Here are my comments about the 40R presentation to date:

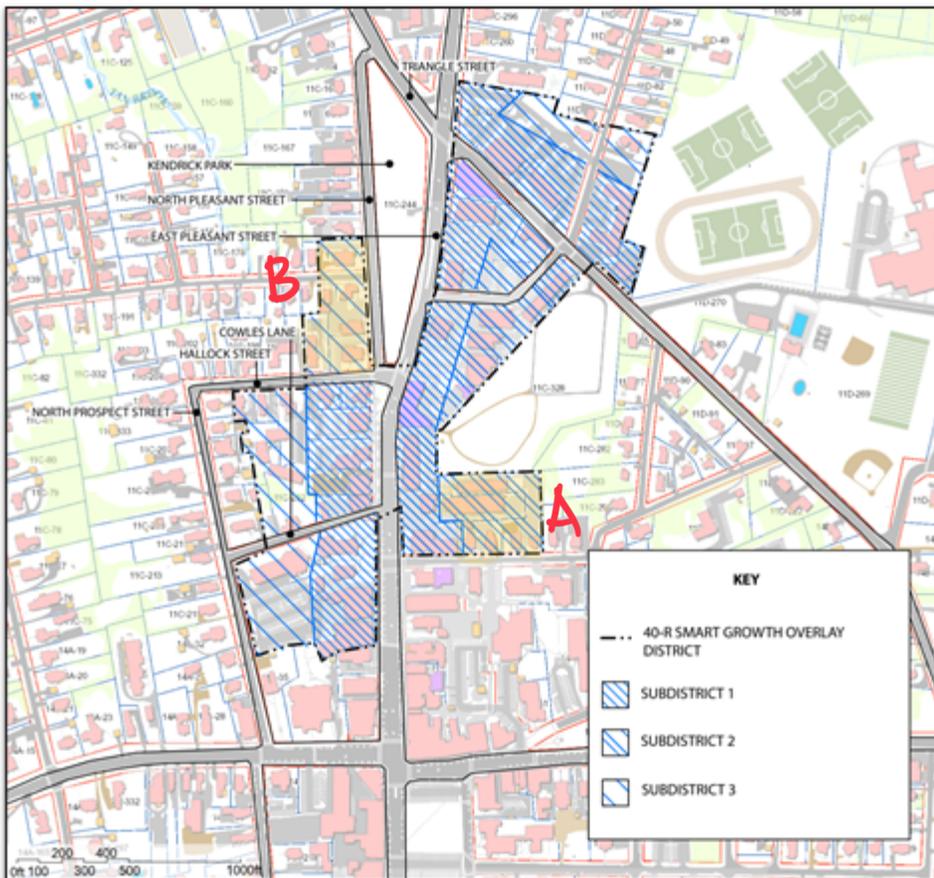
- Delineation lines of the Smart Growth Overlay District: I was asking to be careful about the outlying subdistricts because if they are to be included then each parcel should be closely examined along with their immediate contexts. We don't know the timeframe for the potential projects and if these more outlying subdistricts are built up first would that be a detriment to how the town feels before the main thoroughfare has been developed?

A In particular, the subdistrict 2 behind the Post office + Mobil Gas station: will this be strange if this developed before subdistrict 1 directly adjacent? Subdistrict 3 seems 'safe' as a transition to residential neighbors so perhaps that would be better until main street-side development is underway?

B Another example (going opposite direction in terms of growth): subdistrict 3 west of Kendrick Park: should this go into subdistrict 2? Or a hybrid of subdistrict 2 that has a larger front setback due to adjacency to Kendrick park? Just thinking that SD 3 is pretty much what is there now...40R is to propose densification and unlocking development possibilities.
